Frances/Union and SFU Phase 2 Feedback

Figure 3: proposed layout of the intersection Union St. and Duthie Ave. Source: burnaby.ca

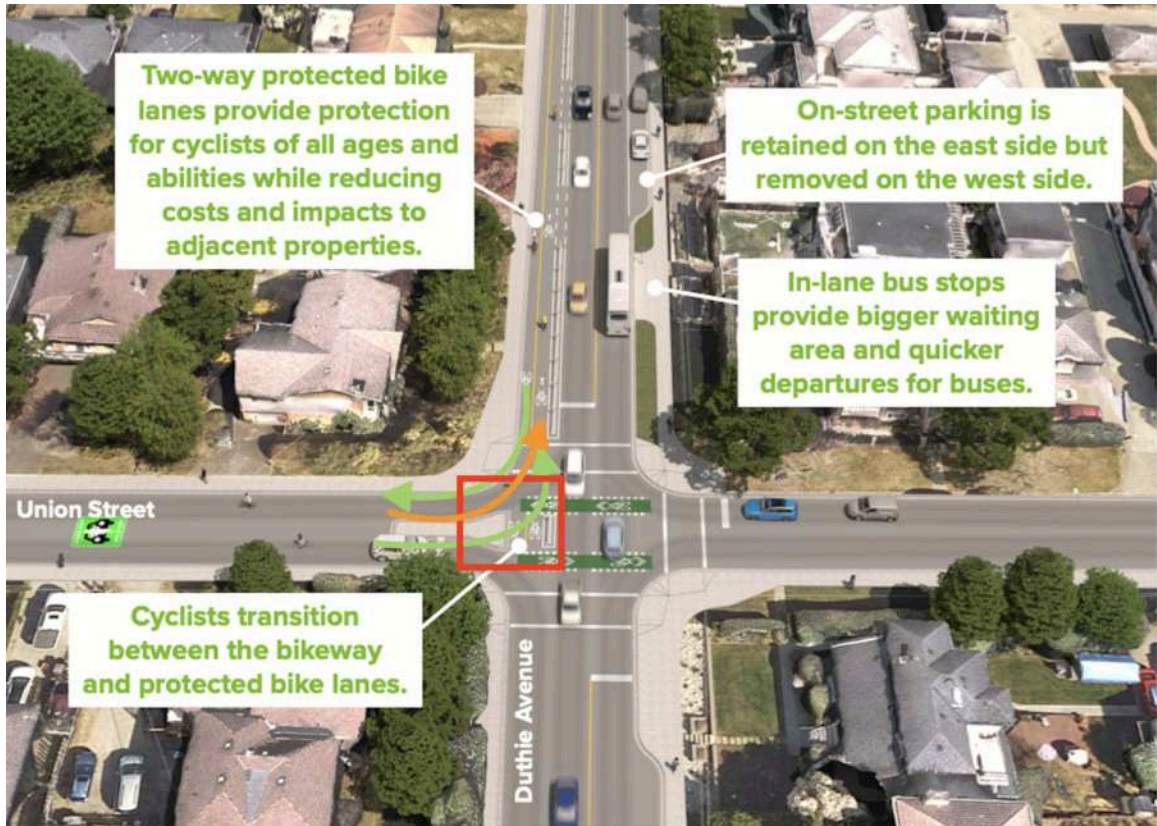
- In Figure 3, we also want to draw attention to the zone in red. In addition to conflicts with people driving cars, there could be conflicts between people riding bikes.
 - We recommend preventing Duthie car traffic from turning west onto Union St.
 - We recommend appropriate signage and a diverter to deter eastbound Union St bike traffic from following the orange arrow in Figure 3.
 - We recommend appropriate signage and a cut through the diverter that helps lead eastbound Union bike traffic onto Duthie.

Figure 4: proposed slip lane and bike path through wooded area. Source: burnaby.ca

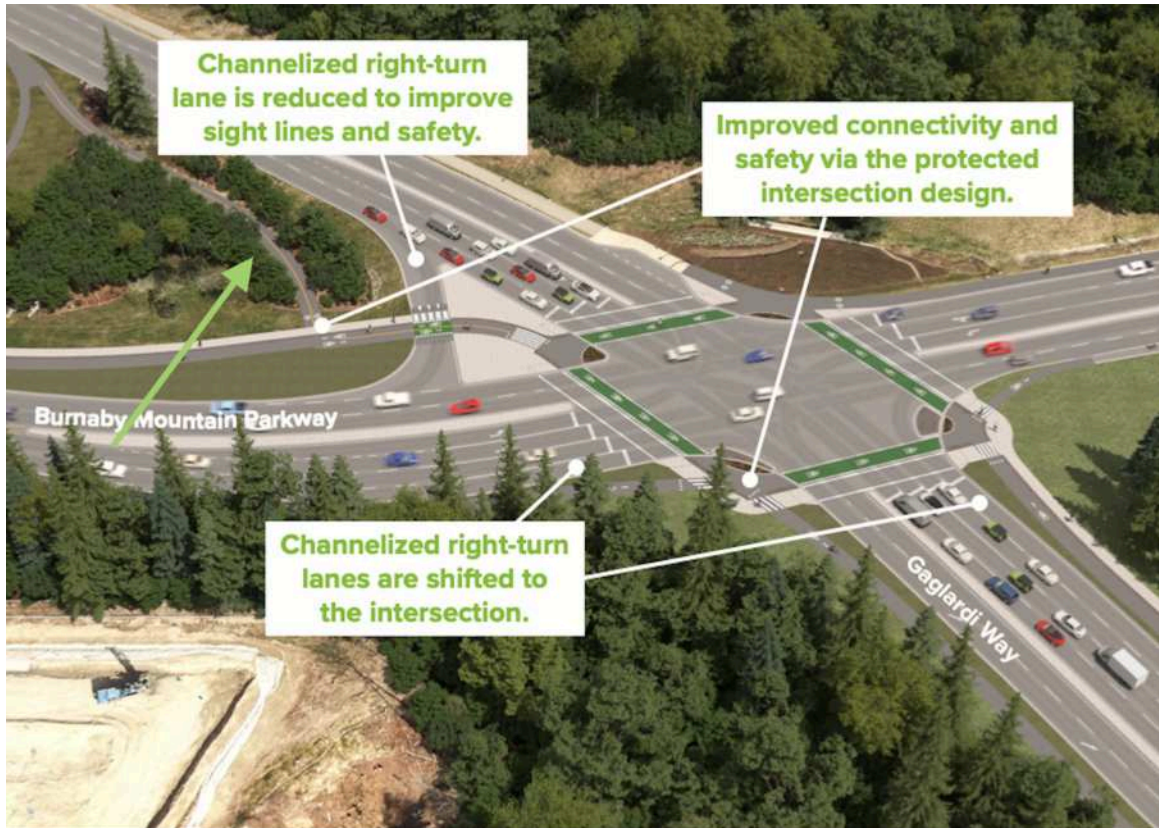
- For the channelized right-turn lane, we are concerned with the use of a slip lane as they pose increased risk for people cycling. If the slip lane must be implemented, can there be additional protective measures such as separate traffic signal phasing, or in-ground detection rectangular rapid flashing beacons (RRFB) that activate automatically when someone cycling triggers the sensor (e.g. Stanley Park Causeway just off the Lions Gate Bridge).
- We recommend adding lights along the path coming down from SFU and cutting through the wooded area (figure 4).
